Customer Satisfaction Notification M04 Engine Oil Addendum Card

2012 (LC/LD) Dodge Challenger SRT and Charger SRT

(LX) Chrysler 300 SRT

2012 (WK) Jeep_® Grand Cherokee SRT

Figure 1 – Owner's Manual Addendum Letter

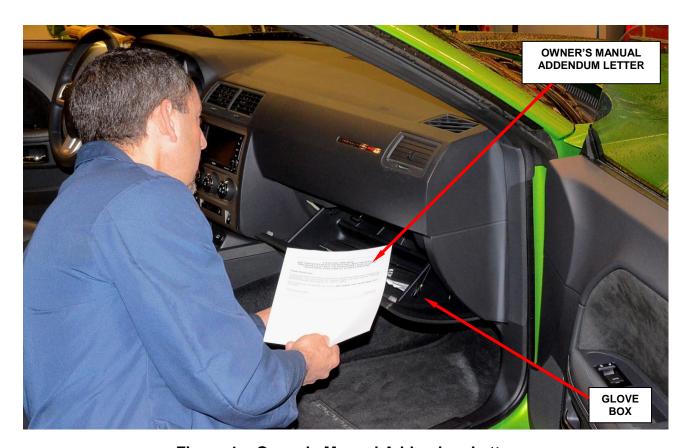
The User Guide on about 110 of the above vehicles incorrectly stated the use of SAE 5W-40 engine oil instead of the correct oil which is SAE 0W-40 full synthetic engine oil.

- 1. Open the driver's door.
- 2. Open the glove box and insert the Owner's Manual Addendum letter into the vehicle's information kit (Figure 1).
- 3. Close the glove box door.
